# Access Compliance Report

## Public Rights-of-Way

Intersection ID: 30315	Main Street: CANNONBALL_DR	Cross Street: EUROSTAR_DR	Location: E
ADA ID: 4E5703788B30	Ramp Type: PerpDiag	Initial Pass/Fail: Pass	Overall Compliance: No
		Severity Score: 15.25

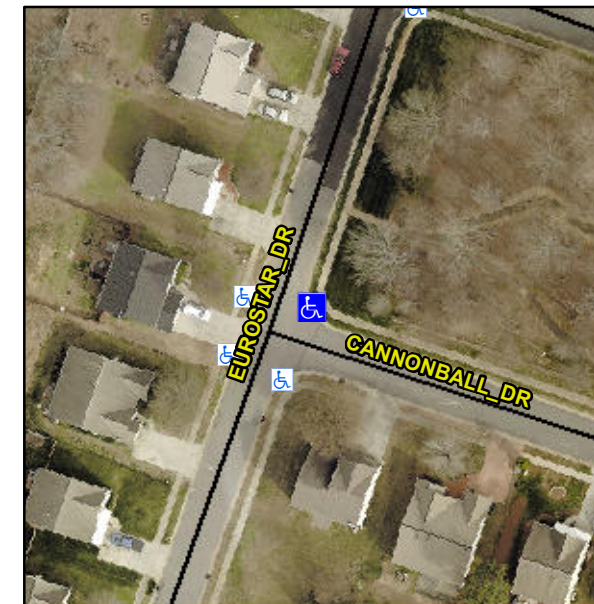
**Not Found, R304.5.3, R304.2.2-Perp, R304.3.2-Para, R305, R304.5.4**

Compliance	Description	Data	Compliance	Description	Data
N/A	Ramp Length (in)	46.0	Yes	Ramp Slope (%)	7.7
Yes	Ramp Width (in)	48.0	No	Ramp XSlope (%)	4.2
N/A	Flare Type LT	Sloped	N/A	Flare Type RT	N/A
N/A	Flare Slope LT (%)	0.1	N/A	Flare Slope RT (%)	8.7
N/A	Flare Traversable LT?	No	N/A	Flare Traversable RT?	No
Yes	Landing Length (in)	48.5	No	DWS Provided?	No
Yes	Landing Width (in)	48.0	N/A	DWS Contrast?	No
No	Landing Slope (%)	2.2	N/A	DWS Length (in)	N/A
No	Landing X Slope (%)	4.9	N/A	DWS Full Width?	No
N/A	Landing Curb? (Y/N)	No	N/A	DWS Offset (in)	N/A
N/A	Shared Landing?	No			
Yes	Gutter Ponding?	No	No	Gutter Slope (%)	10.7
Yes	Gutter Lip Ht (in)	0.0	No	Gutter X Slope (%)	4.8
N/A	Painted X Walk1?	No	N/A	Painted X Walk2?	No
	X Walk 1 Direction	To NW		X Walk 2 Direction	To SW
N/A	X Walk 1 Width (in)	N/A	N/A	X Walk 2 Width (in)	N/A
	X Walk 1 Slope (%)	6.5		X Walk 2 Slope (%)	0.4
	X Walk 1 X Slope (%)	0.2		X Walk 2 X Slope (%)	4.2

**Remove & Replace Curb Ramp With Two New Directional Ramps or Equivalent. Remove & Replace Gutter.**
